Addendum Assessment Report

DA6/2020 - Community Facility (Cultural Precinct,
Library and Archive)

Active Planning Consultants

Plan detail: highlighting the new gable roof in yellow to match the existing roof

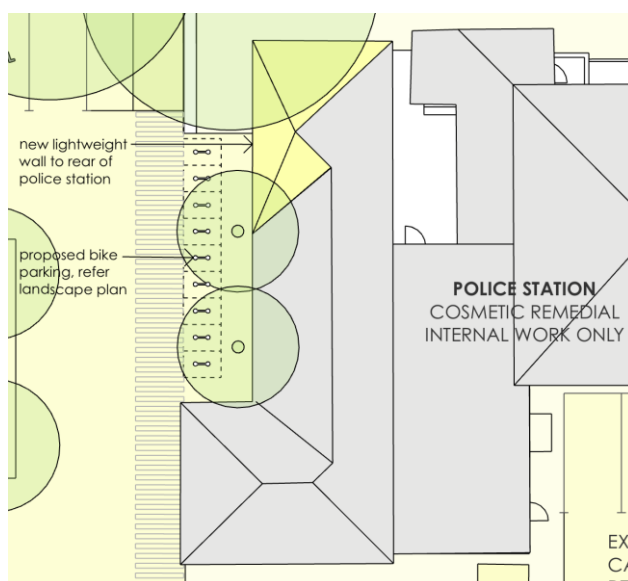
The demolition of the rear of the heritage Police Station building itself (not the demountables and separate buildings) is described as non-significant (face brickwork, not original brickwork) in the SoHI. Please describe / illustrate how the roof and wall edge exposed due to the partial demolition will present given the public exposure facing the carpark, new square and main building entry, and confirm this is suitable / acceptable?

The 'cut' end to the Police Station – facing northwest to the new carpark - will expressed as a 'cut', presenting as a singular new insulated blank wall of horizontal painted weatherboard. The scale of the cladding will match that on the rear side wall of main Police building. Egress will remain via the existing door to the small courtyard on the cooler south-east side of the building.

It should be noted that the area proposed to be removed is a later addition. It may well be that original external walls remain extant. If this is the case, then every effort will be made to make visible the original walls, as has been the approach in the proposed Archive. Access to the building has been limited due to current police operations, and detailed investigative works not possible until the premises become vacated.

North elevation: highlighting the new lightweight wall and gable roof in yellow. The adjacent single storey building roof remains intact with existing masonry walls revealed.

- APC Comment** - The NM+N response to the WRPP question provides greater clarity on the how the roof and wall edge of the heritage listed Police Station will present to the carpark, new square and main building entry. NM+N advise the demolition works to the western side of the Police Station will expressed as a cut through the existing brick wall and finished as a singular new insulated blank wall of horizontal painted weatherboard. The elevation plans show how the end brickwork of the existing northern wall will be revealed as a clean cut edge to the new western wall of painted weatherboard. The plans also show how a new gable roof will be installed over this part of the building to match existing. NM+N advise the scale of the cladding will match that on the rear side wall of the main Police building. Egress will remain via the existing door to the small courtyard on the cooler south-east side of the building. NM+N advise Paul Davies Pty Ltd (Architect who prepared the Broken Hill Library, Archive and Community Hub Heritage Impact Statement, dated December 2019) has reviewed these details and raises no issues of concern. Given the materials / setbacks proposed from finished western walls to parking, walkways, bike storages and landscaped areas, it is assessed the building façade treatment strikes the right balance of historic building fabric interpretation, aesthetic appearance, functionality and solar access treatment to complement the Police Station, public carpark, new square and main building entry. No changes to submitted plans or recommended conditions of consent are considered necessary.

Site plan location options 1, 2 and 3 for the bin store and locations A and B for the mechanical plant are noted in bold blue font.

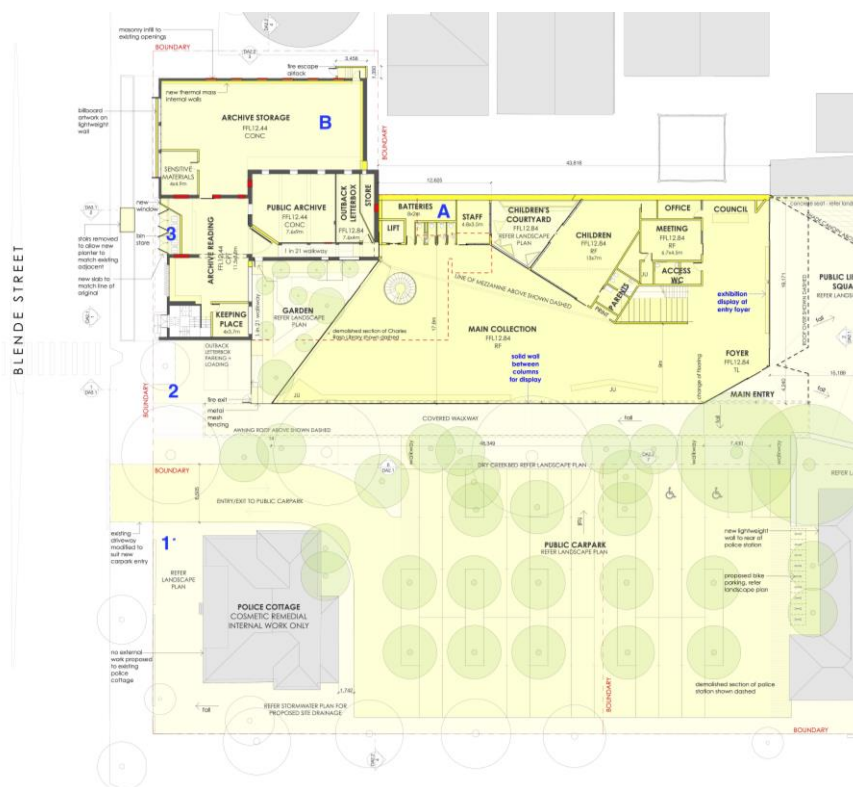
The assessment report notes that Blende Street is a significant streetscape and impacts are minimised, and hence supports the alterations (including screened bin store) and roof top plant. Were any alternatives to bin storage and roof top plant storage considered (I accept why these are not sited elsewhere given the external heritage interfaces and new public interfaces, but just want to be satisfied not at expense to Blende Street). Please also clarify how the parking / loading bay for letterbox library will operate, given its location at a key pedestrian linkage through the site (conflict and/or turning of vehicles), or is this occasional use only and manageable?

- Location 1 - north of the police cottage. This was considered operationally too far from the main library and crossing the public carpark driveway was not preferred from a safety perspective.*
- Location 2 - north of outback letterbox parking. As a standalone screened storage area this was not preferred as it would detract from the existing Blende St streetscape. Visibility was also an issue with this location, as the bin store would have blocked views from the Blende St pedestrian entry to the proposed library, as well as the outback letterbox parking. This location was therefore not chosen for safety and visibility reasons.*

- *Location 3 – locating the bin store behind new perforated metal mesh doors that integrate with the existing façade and conceal their purpose when viewed from Blende St. This option was considered the most in line with preserving the existing Blende St façade and allows access via existing graded footpath – discrete and operational.*

- *Location A - on the roof of the library building above services rooms. The amount of plant (and associated circulation) required would not have been able to fit in this location. Although it would have been less visible from the street, by lowering the plant roof there was risk of water ingress to the server room below. This location being further from the archive rooms (requiring specialist A/C equipment) also would have meant increased lengths of visible ducting, which in turn complicated safe roof access between the archive and library roofs. This location was therefore not chosen as the proposed option.*

- *Location B (proposed in DA submission) - roof of the archive storage allows the length and visibility of specialist A/C ducting to reduce as it is closest to the rooms it services, concealed behind an acoustic metal screen, set as far back as possible from the Blende St facade to allow clear views to the majority of existing level 1 windows from the Civic Centre, Chloride St and Blende St.*

-
- **APC Comment** - The NM+N response to the WRPP questions about the location of bin, plant and letterbox storages provides greater clarity on their consideration of alternative locations for these facilities, including choosing their preferred locations based on streetscape, functionality and safety / visibility criteria. The locations for bin, plant and letterbox storages are assessed to be logical / practical and will not result in significant impacts on adjoining properties / streetscape. No changes to submitted plans or recommended conditions of consent are considered necessary.
